**Rockland County Solid Waste Management Authority**

#### RFP 2021-13

#### **MECHANICAL**

SUBJECT: ADDENDUM NUMBER 4

M-101 **DESIGNED** BJZ **RRT Engineering , LLC** CAD FILE: N:\2021\21033\MEP\21033 M-101.DWG APPROVED ph: 631-756-1060 fax: 631-756-1064 APPROVED SHEET SIZE: D-24x36

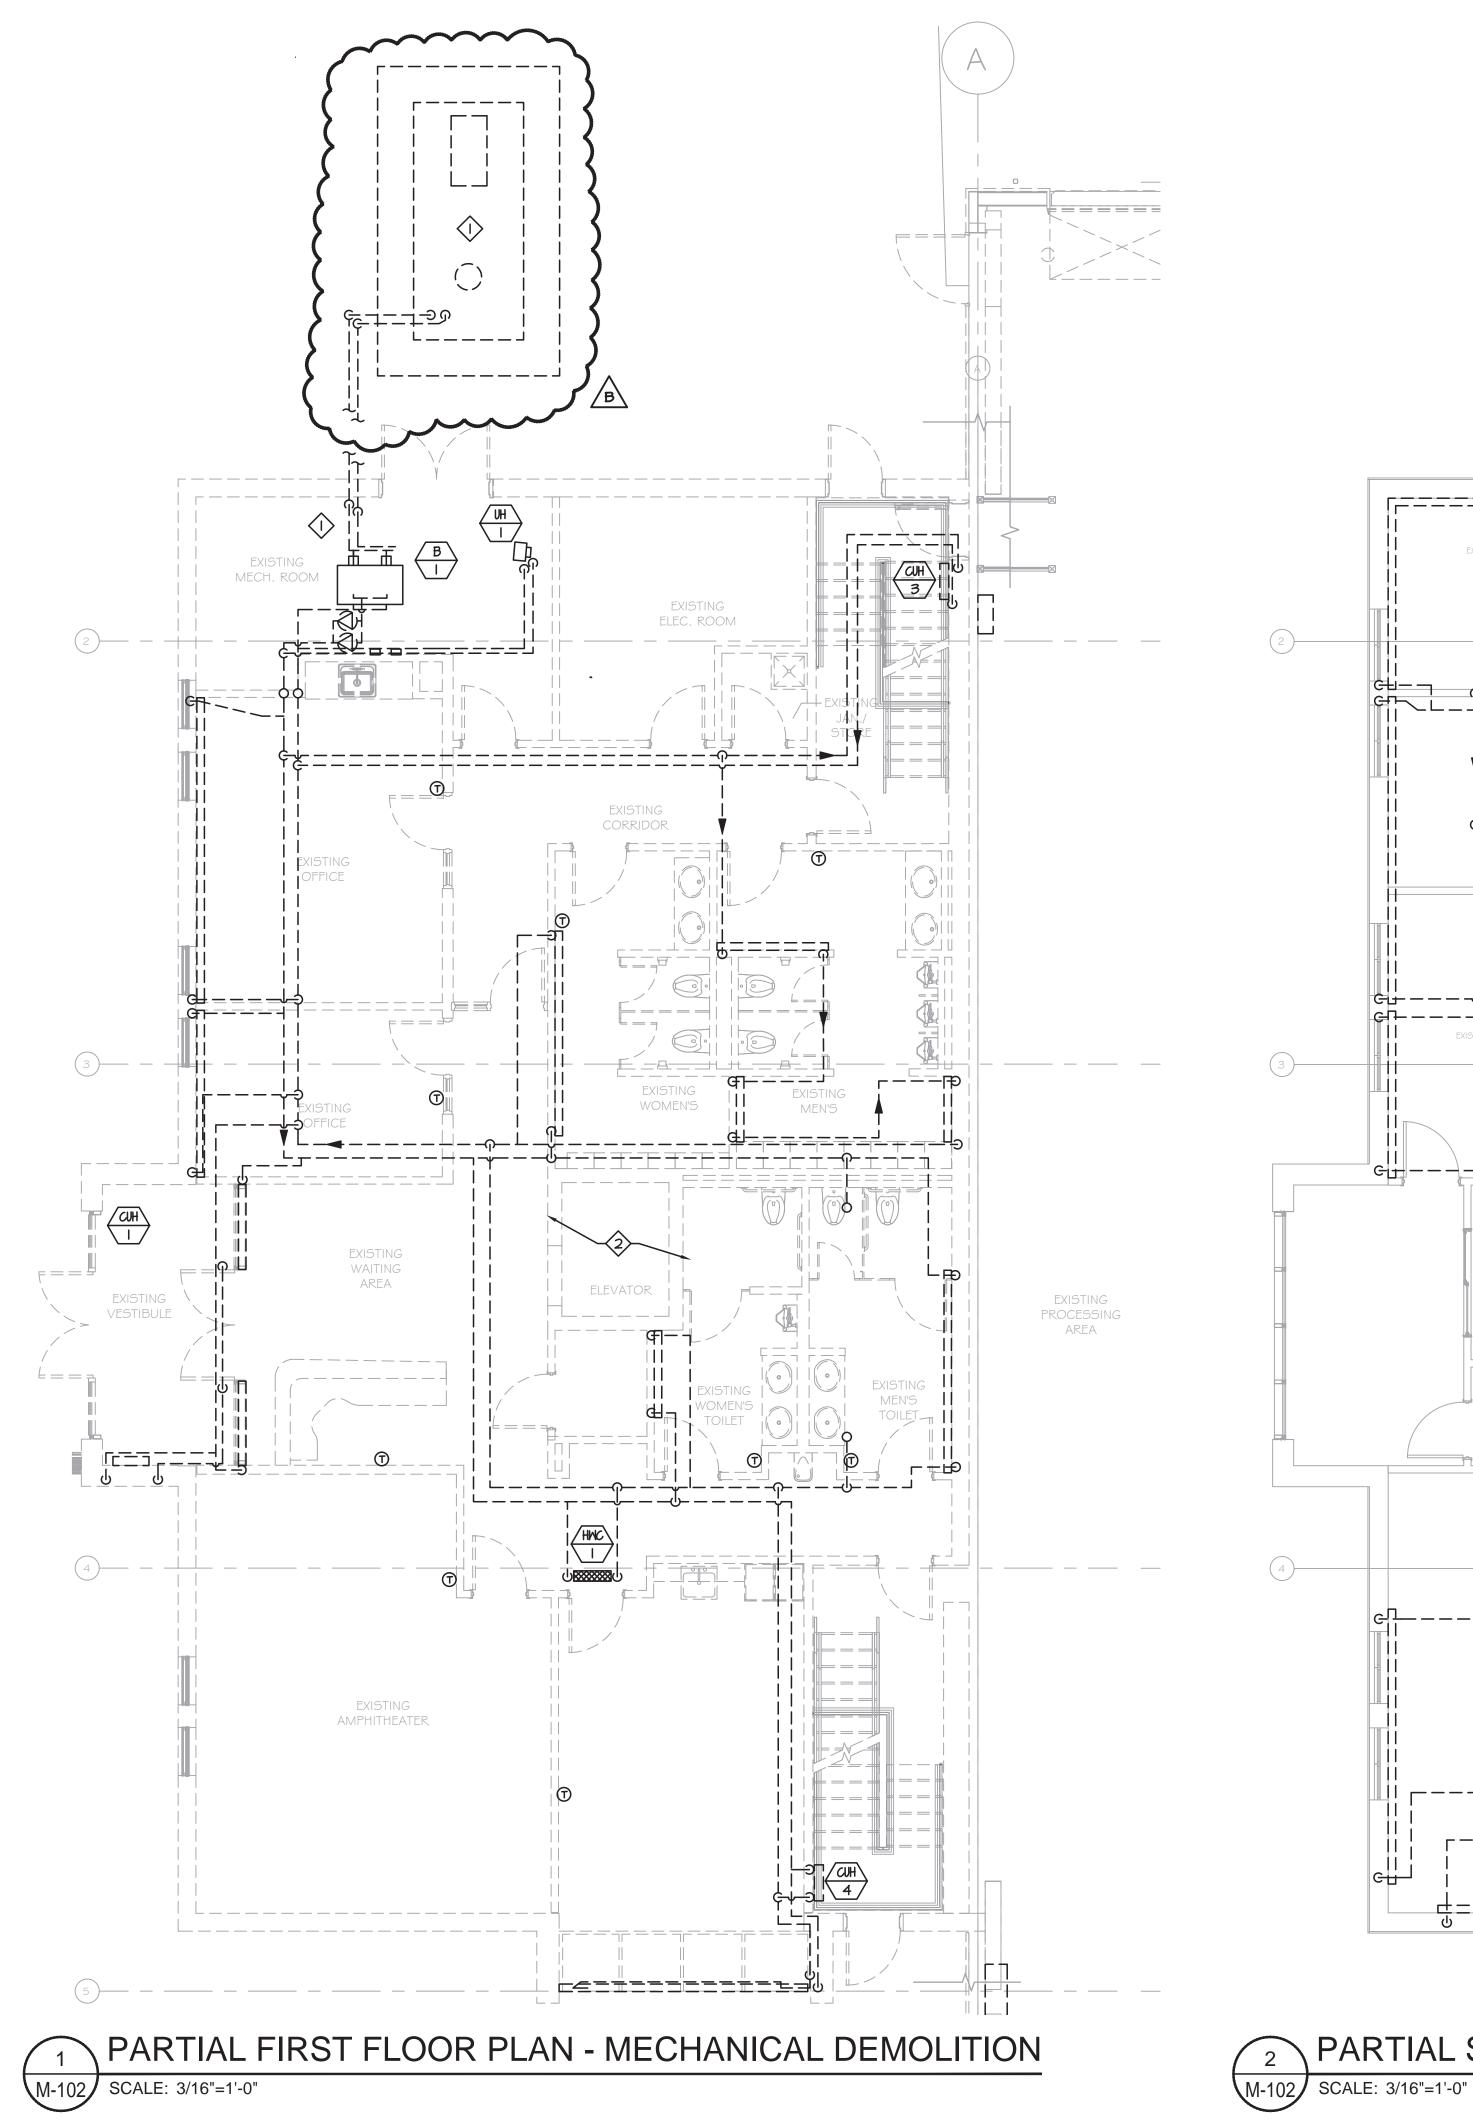
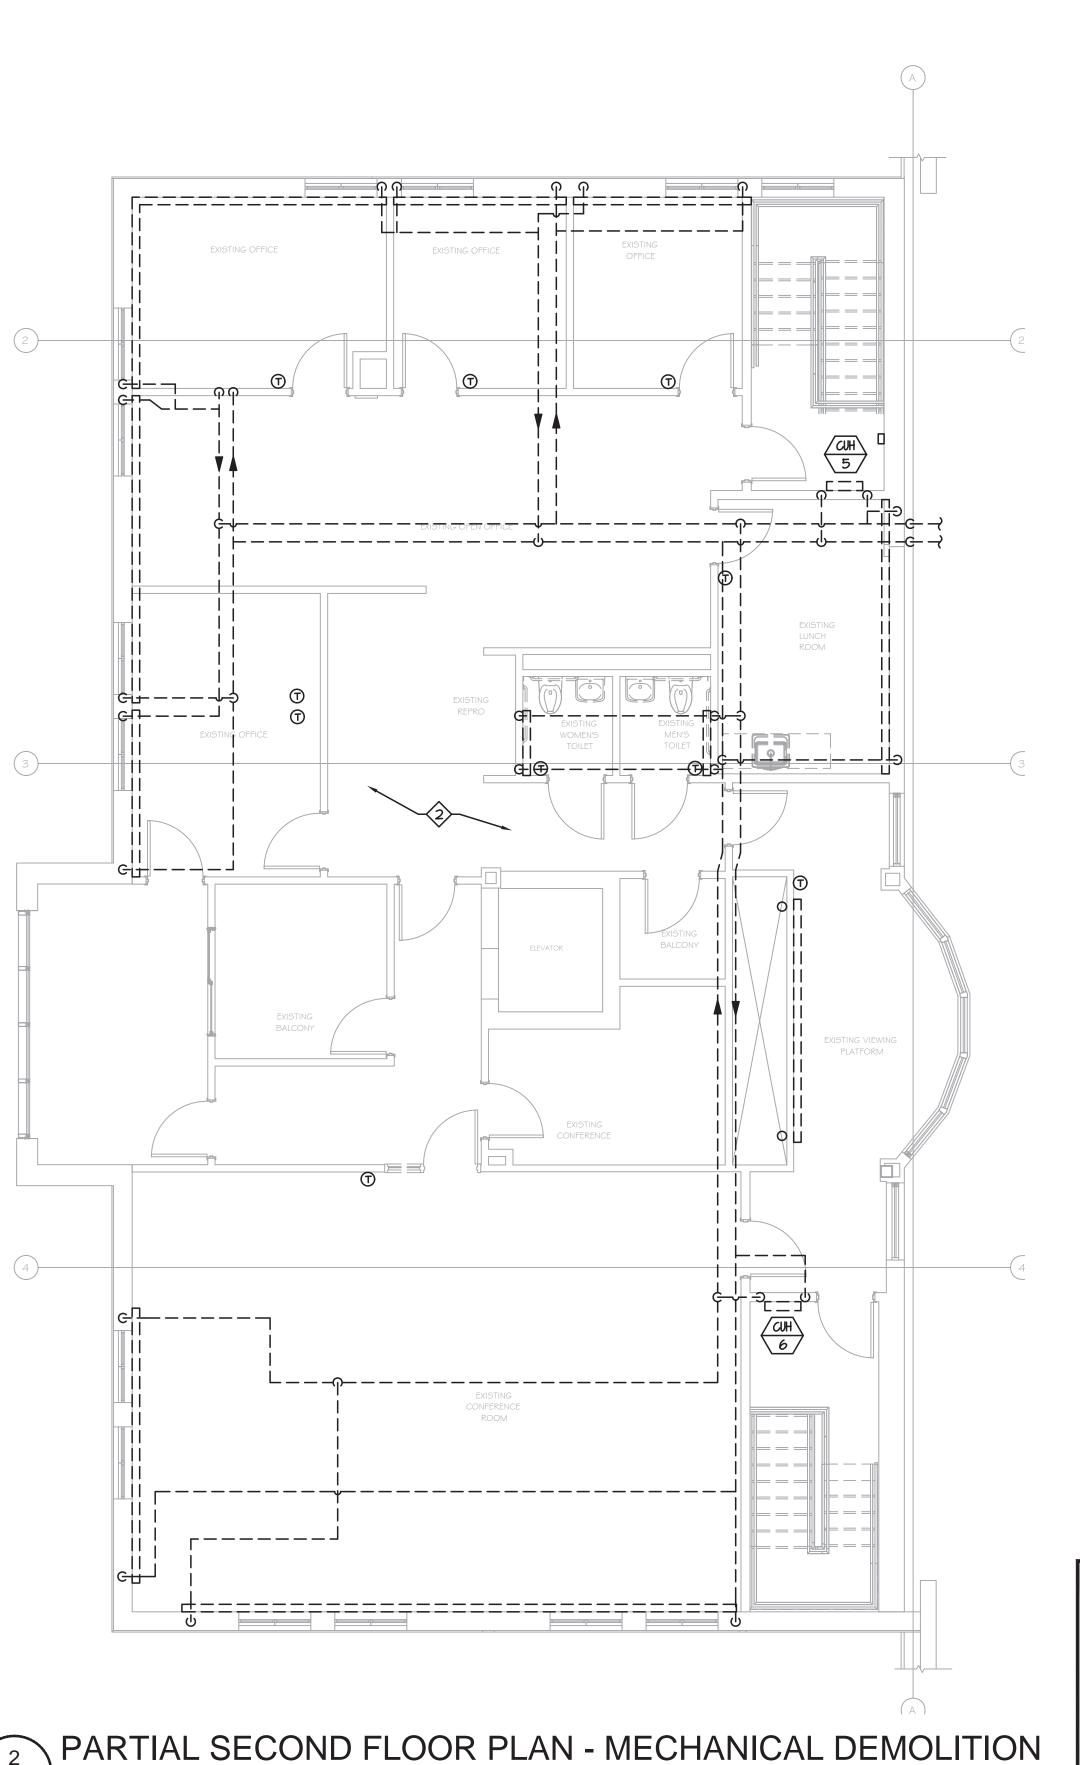
- 1. Drawing M-001
  - A. Updated Mechanical Drawing Schedule.
- 2. Drawing M-002
  - A. Added this drawing.
- 3. Drawing M-101
  - A. Removed combustion and ventilation air louvers in Existing Boiler Room.

- B. Removed exhaust fan, louver and electric unit heater in Existing Electrical Room.
  - C. Revised Demolition Notes.
- 4. Drawing M-102
  - A. Added oil tank and piping.

**DESIGNED** BJZ CAD FILE: N:\2021\21033\MEP\21033 M-102.DWG APPROVED

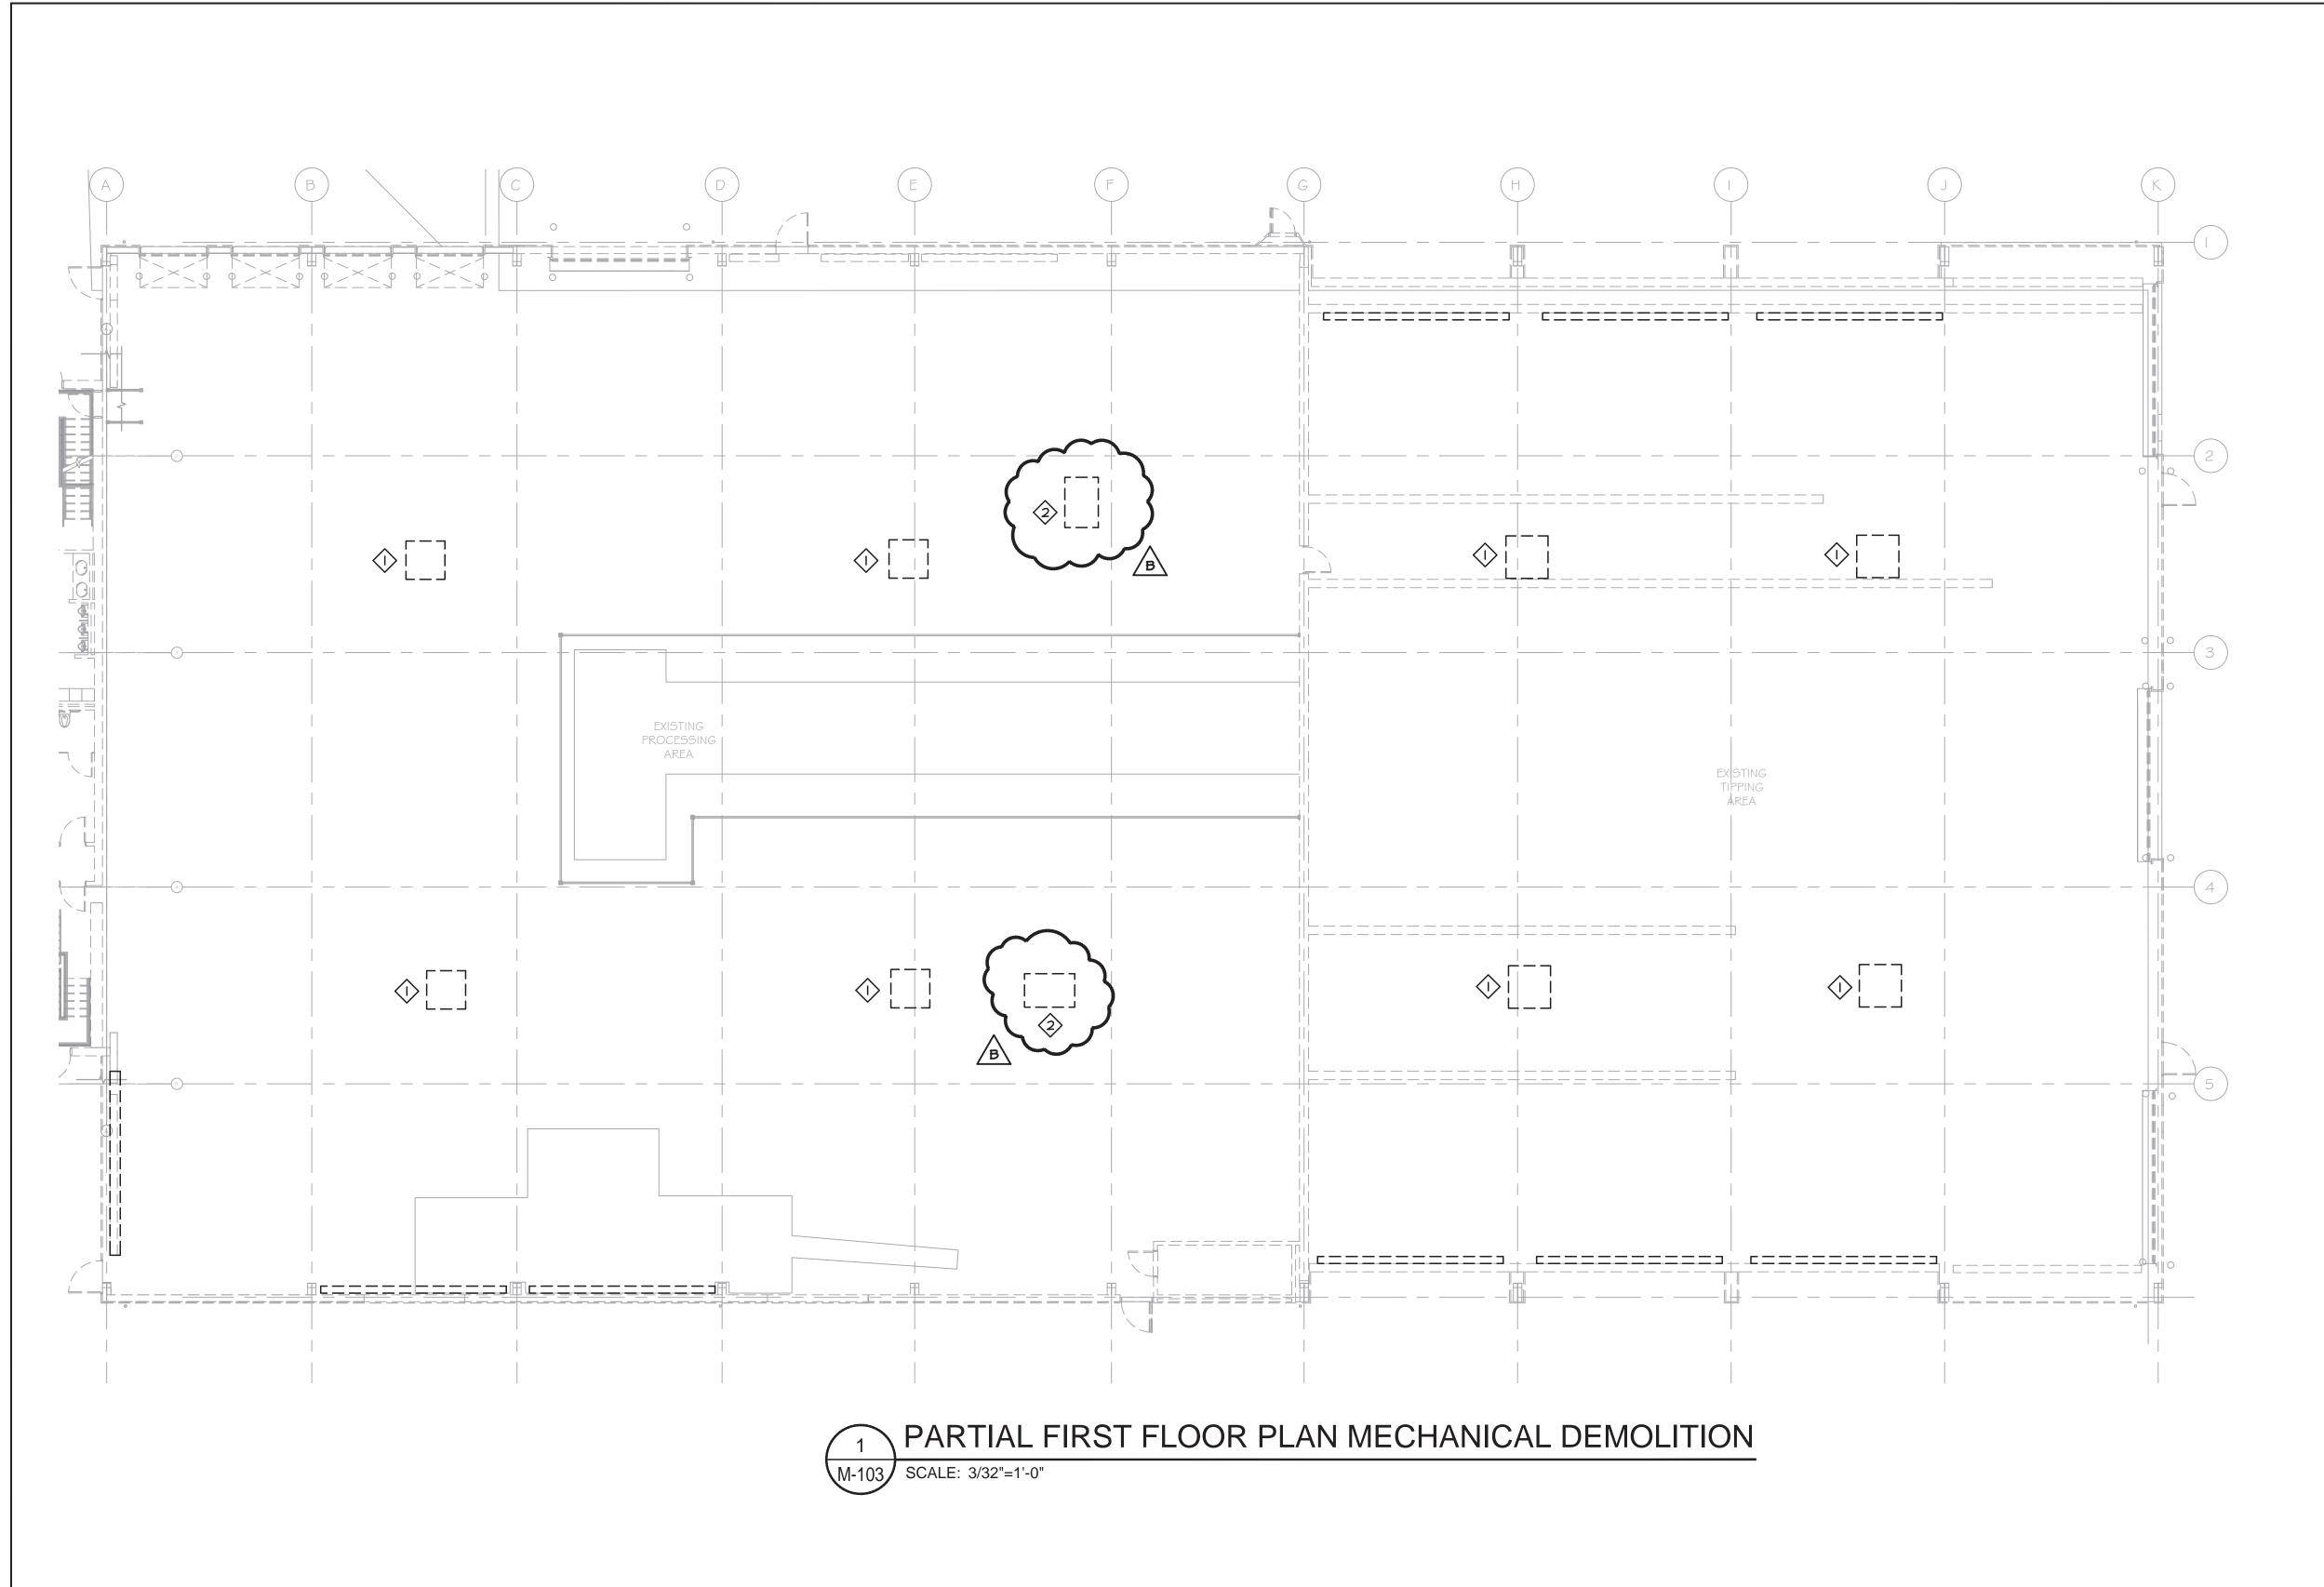
- B. Revised Demolition Notes.
- 5. Drawing M-103
  - A. Revised Demolition Notes.
- 6. Drawing M-201
  - A. Added intake louver, exhaust louver, exhaust fan and electric unit heater to Electrical 113.
